PROPOSED CHANGE NO. SC-01-002R1

Date: July 24, 2025
File: 9.1.7.4.2_SC-01_PC
Project No.: 2215C
Project: TA Blakelock HS Reno - Phase 3
Subcontract: SC-01 General

Description: Elevator 2 (drama area)

CONTEMPLATED CHANGE NOTICE No. S1

6 PARTIAL FLOOR PLAN - LEVEL 2 & ROOF
A100 1:50

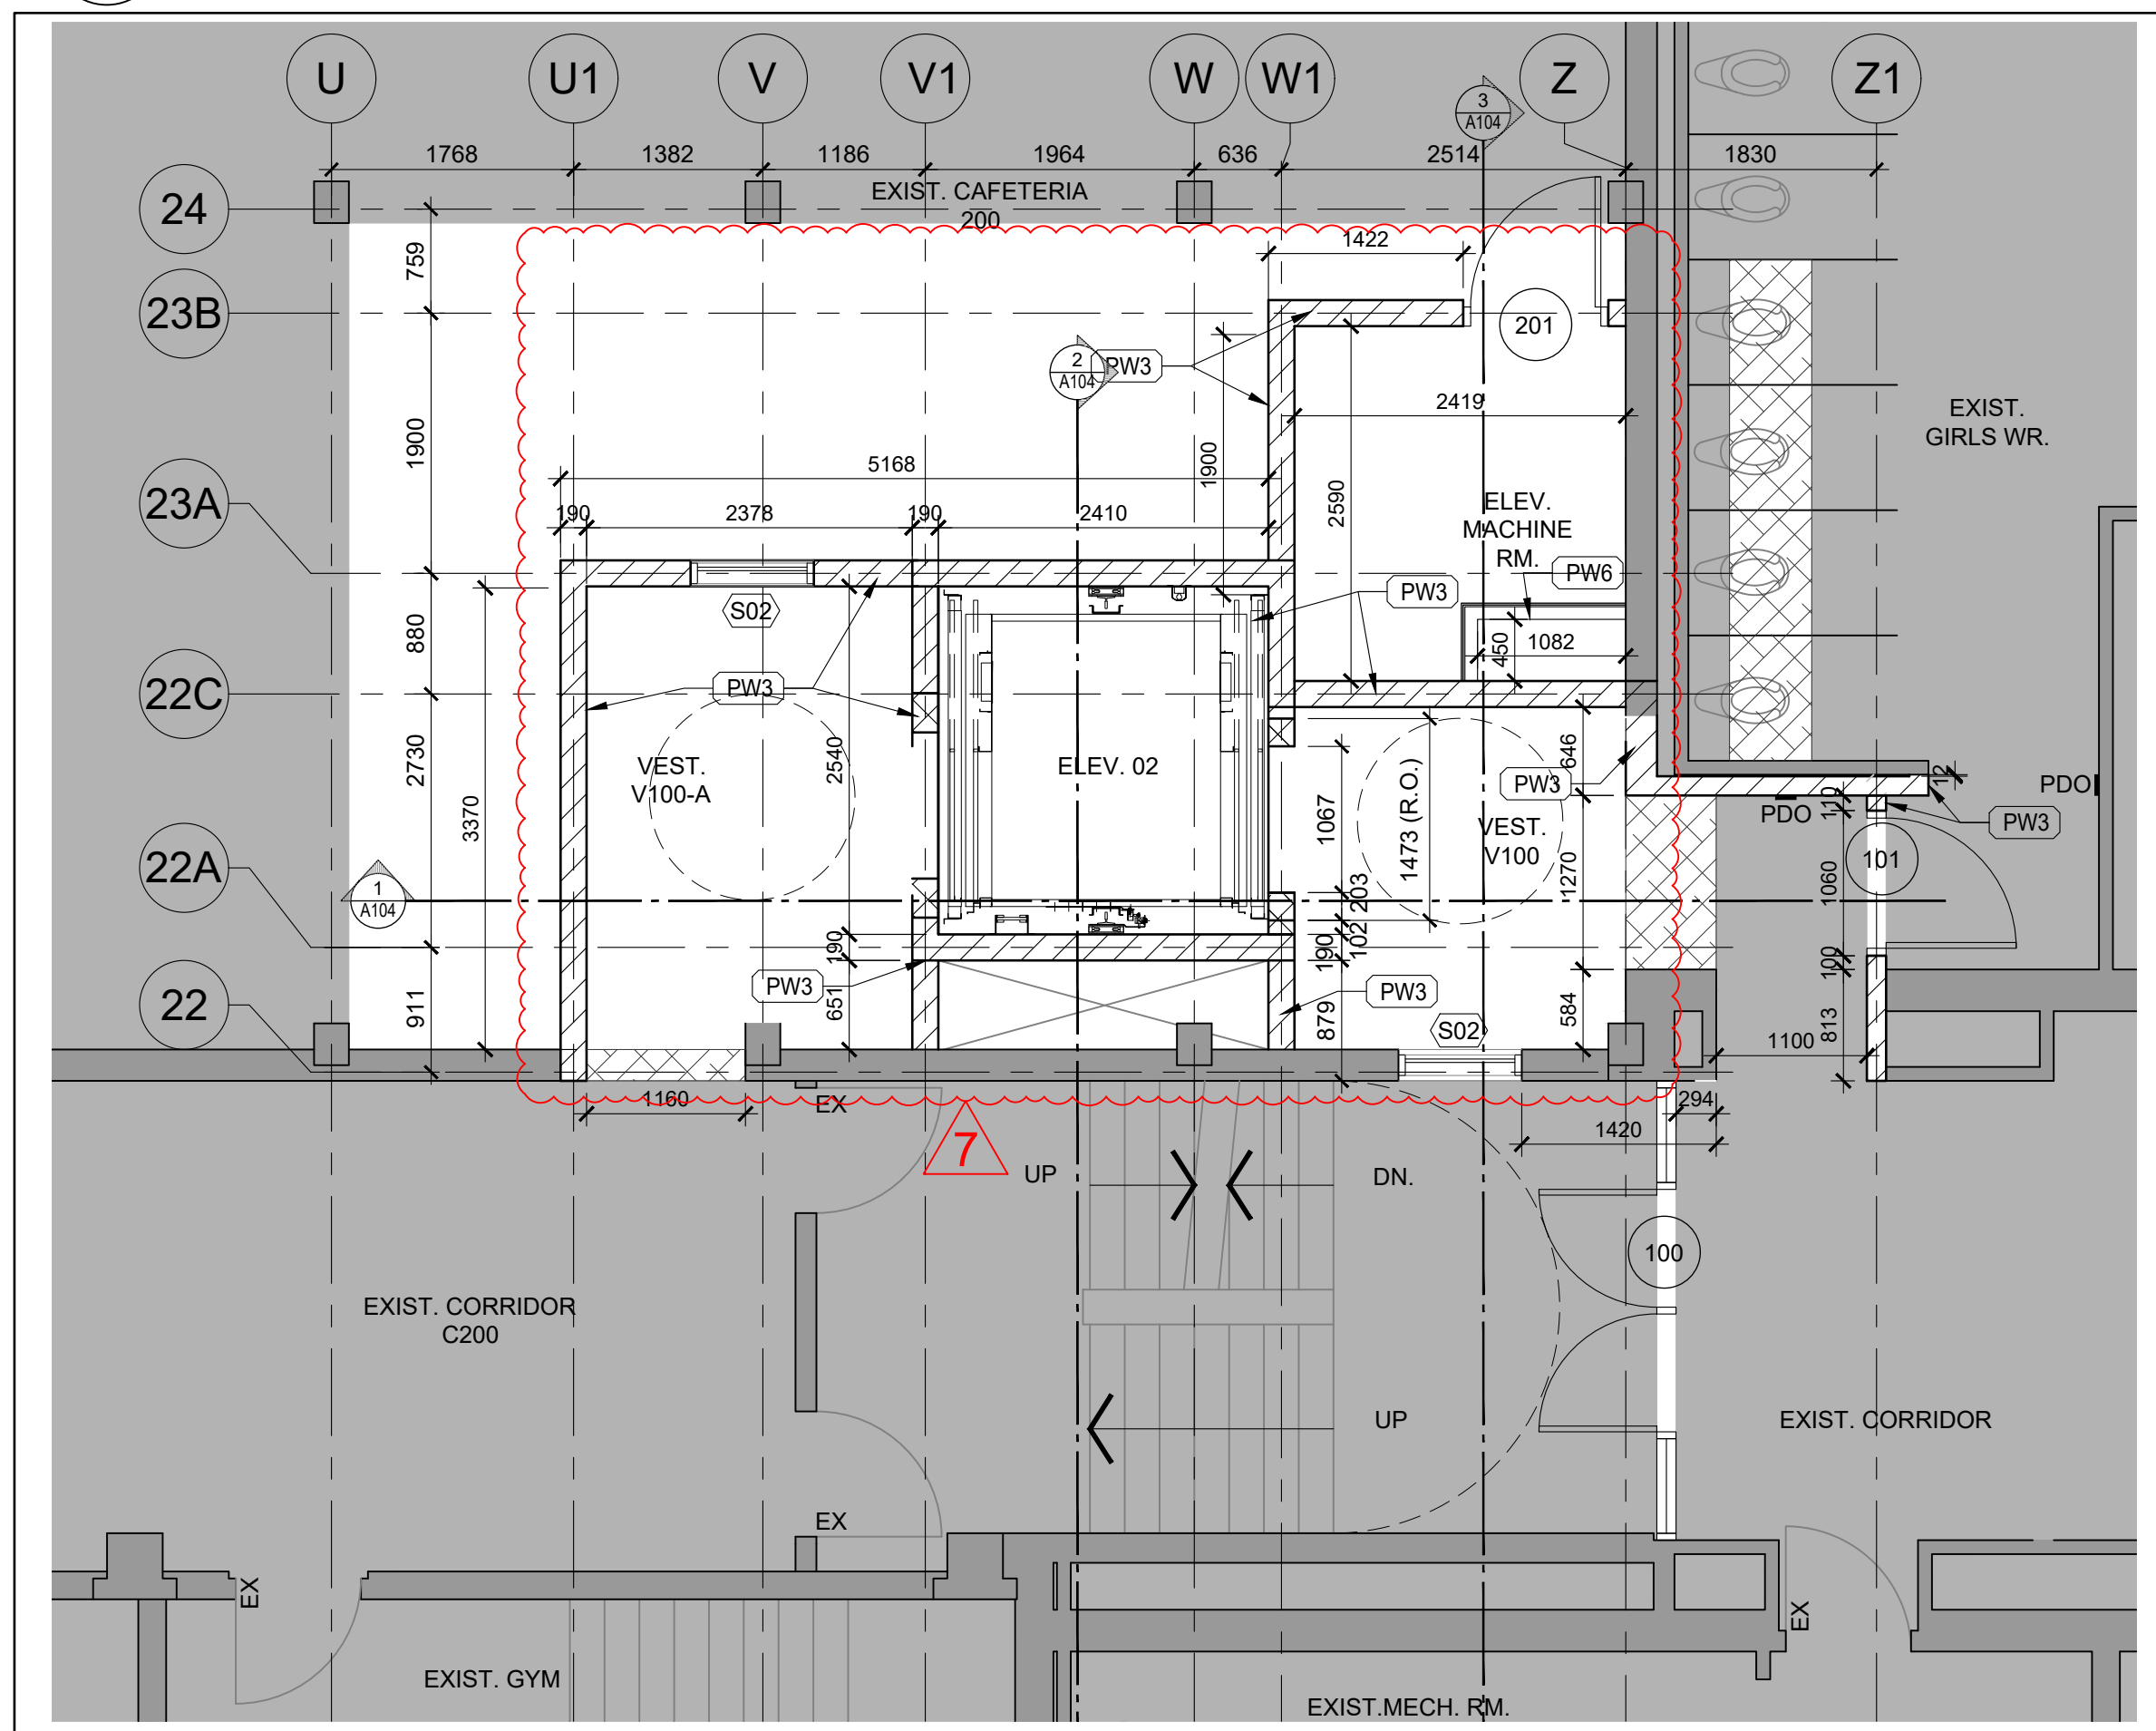
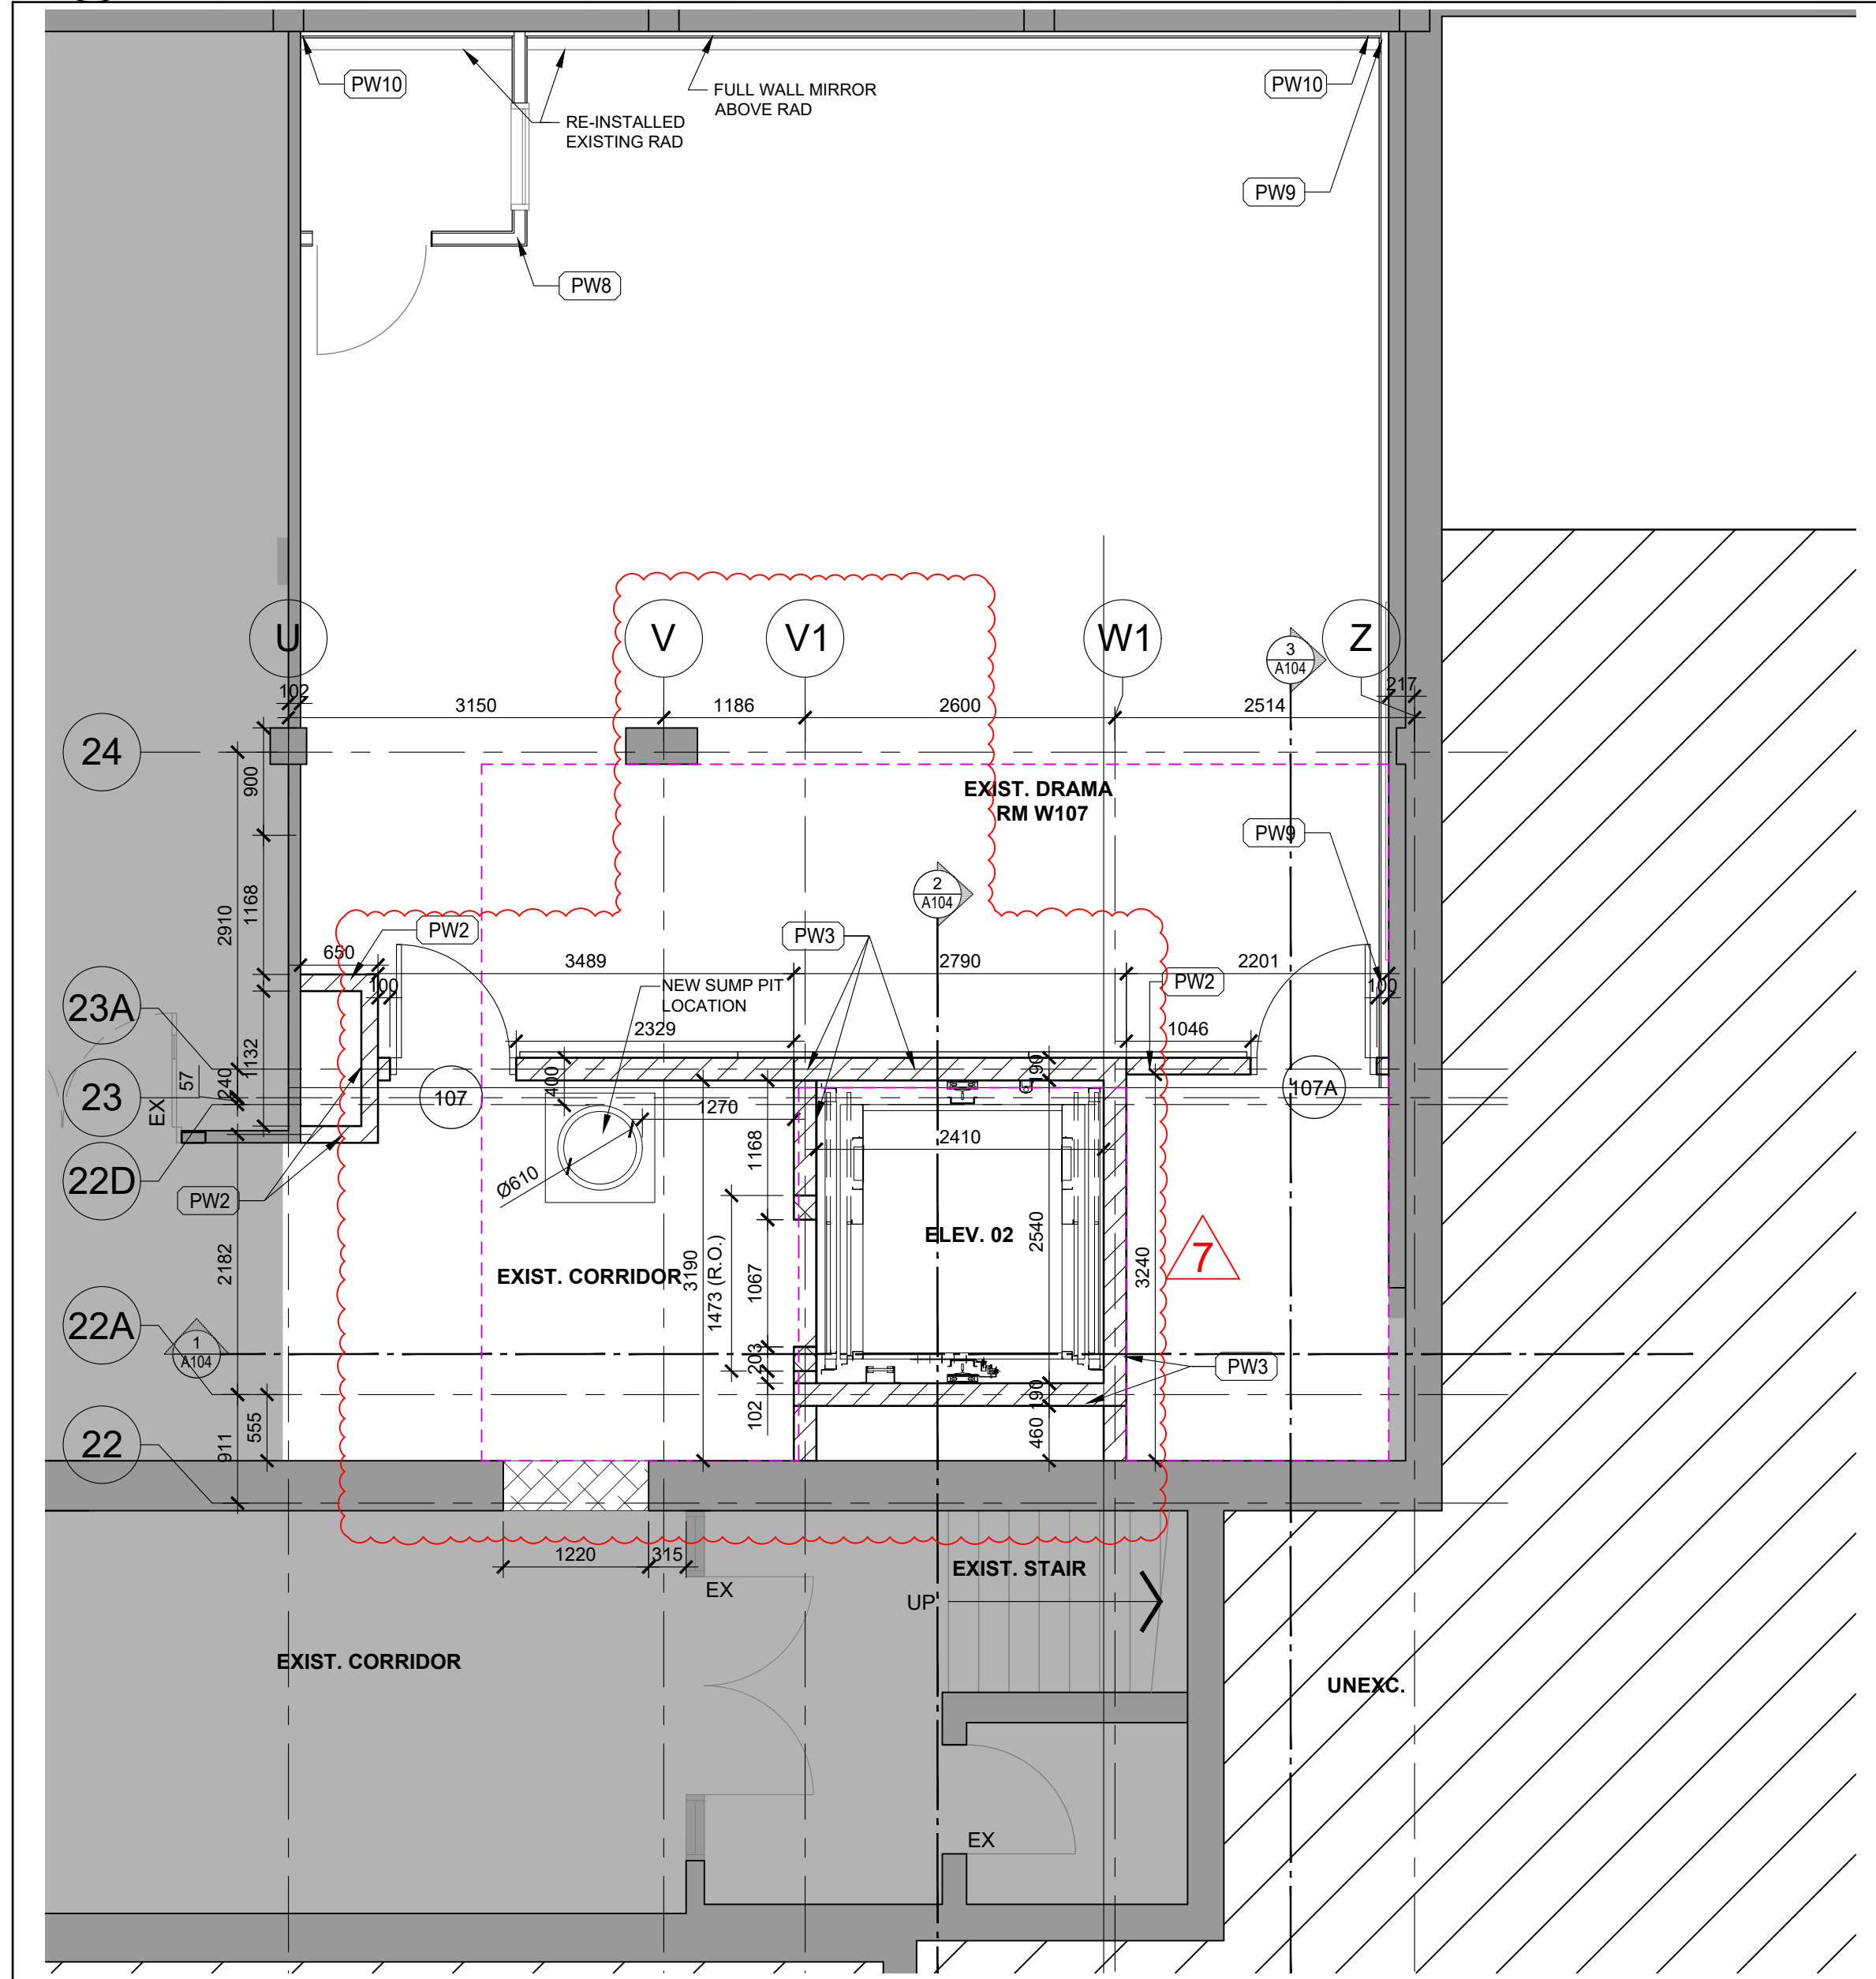
1. Refer to attached updated A100 floor plans and A104 updated sections.
2. Refer to Structural CONTEMPLATED CHANGE NOTICE No. S1 item 1 for requirements.
3. Mechanical CCN to follow adjusting sump pit location and corresponding drainage and piping to it. Electrical CCN to follow confirm power and control until location for sump pit.
4. Refer namely to sump pit relocation, deletion of underpinning along West side of Drama Room (Refer to Structural CCN for scope).
5. Provide 36x 36 ACUDOR FT-8050 concrete floor door, single leaf, 1" recessed to receive flooring. Provide cut sheet. Note this ACUDOR is intended to clear the 24" dia sump pit including sump pit flange. Confirm with vendor. Set sump pit lid just at u/s of lid opening. Provide cut sheet of ACUDOR. Run sump pit venting and discharge line within adjacent 190mm CMU wall.
